**PUBLIC INTEREST REVIEW FOR GROUND WATER APPLICATIONS**

SUBJECT: Application G- 17365 Supersedes review of May 7, 2010

**A. GENERAL INFORMATION:** Applicant's Name: Andy Root County: Harney

# Application G-17365, Andy Root (Rereview)

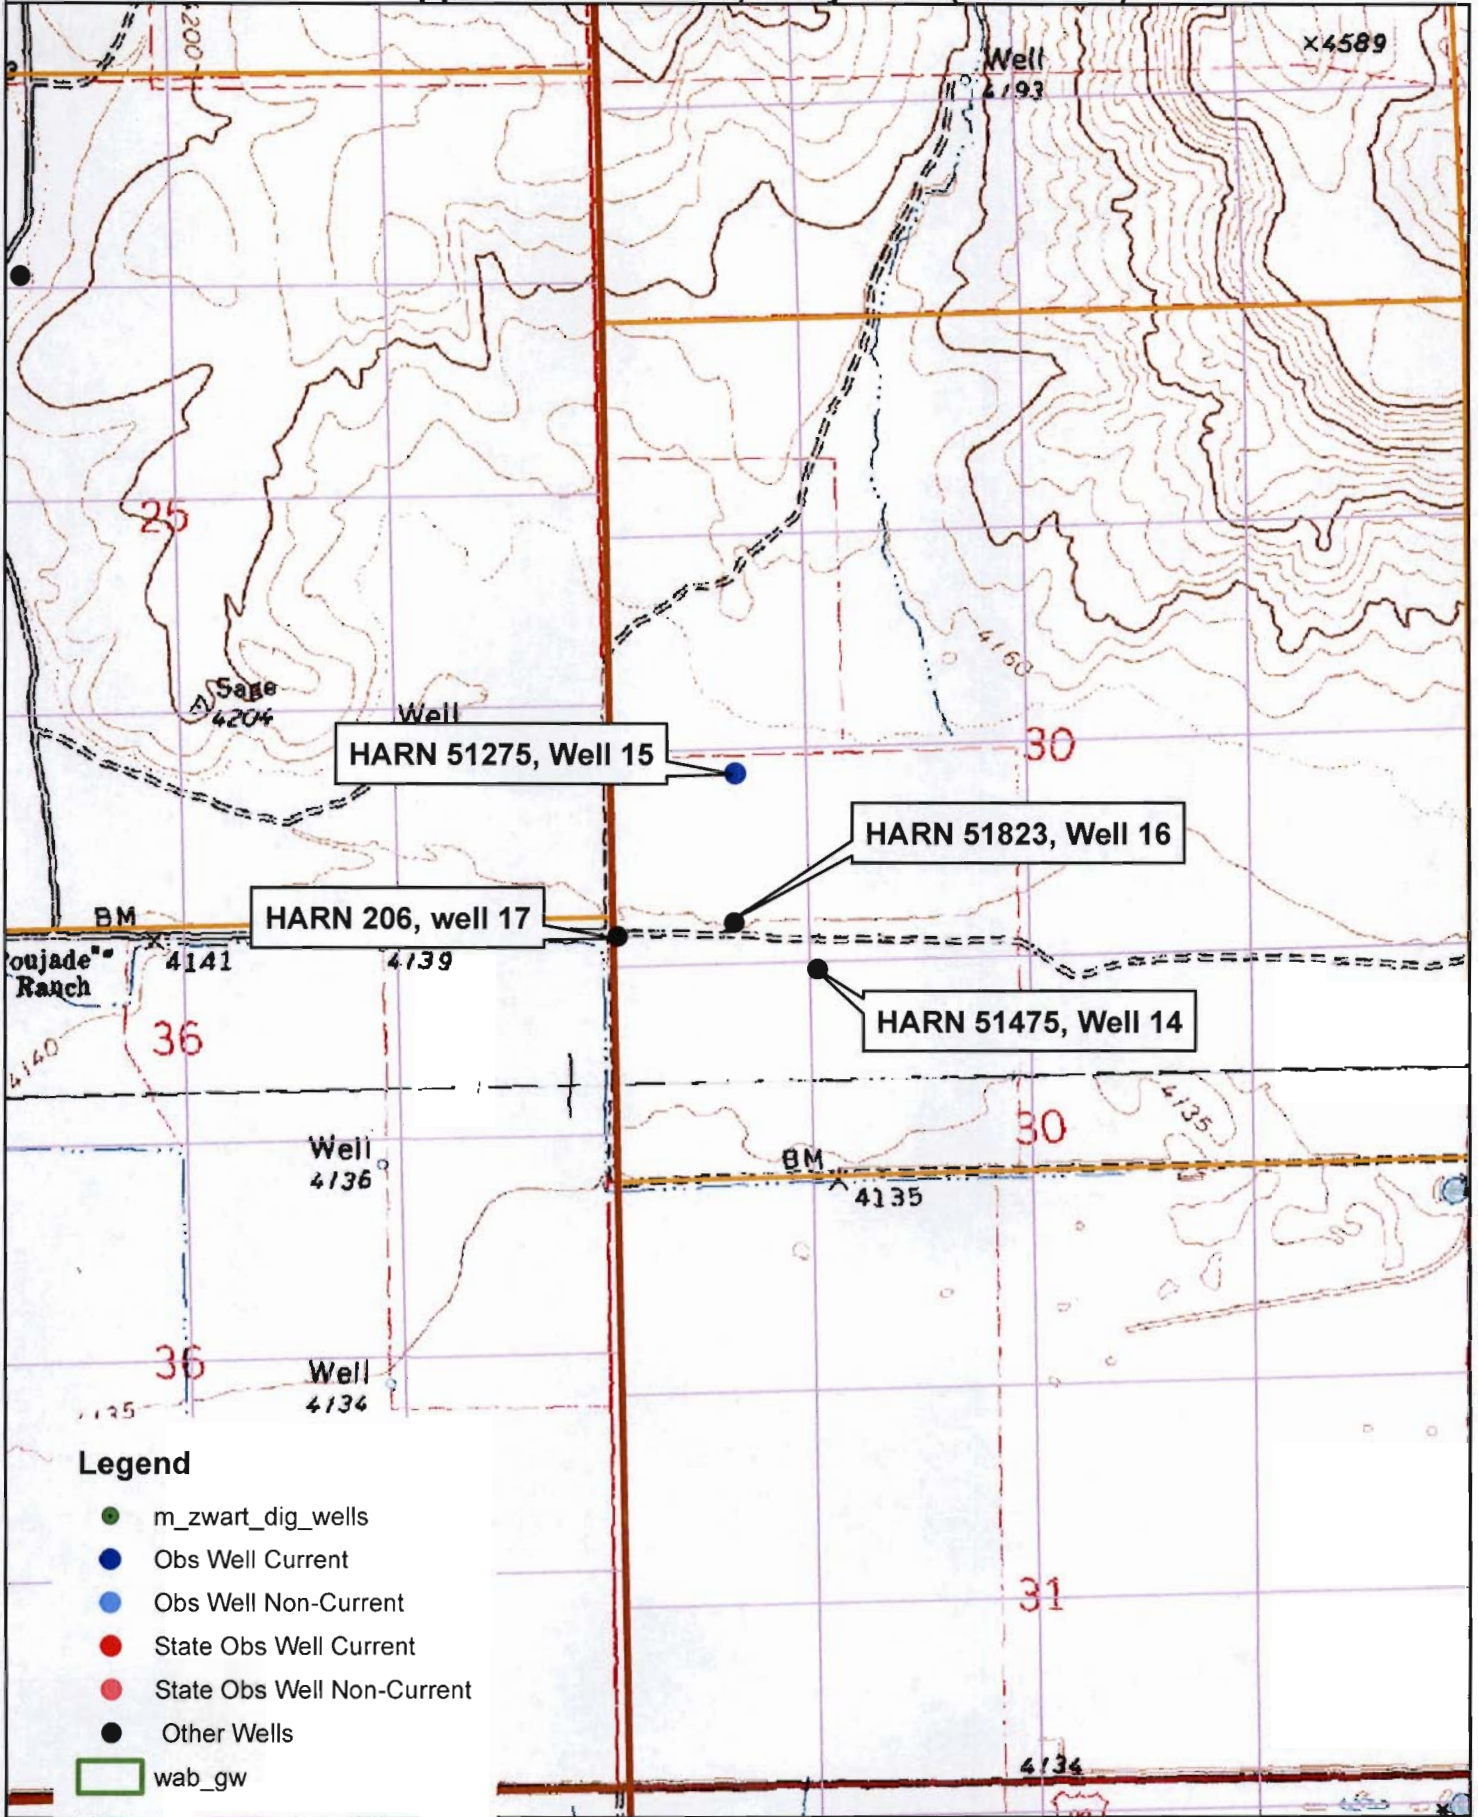
**Basis for aquifer confinement evaluation:** Locally, the aquifer may be semiconfined to confined, but regionally it is unconfined and discharges to Malheur Lake. The wells appear to develop a confined aquifer below a thick clay or claystone.

**Basis for aquifer hydraulic connection evaluation:** These creeks are intermittent and likely contain water only in very wet years. Ground water likely provides negligible baseflow to these creeks.

D4. **THE WELL construction deficiency is described as follows:** No deficiency is noted, but the well is quite old.
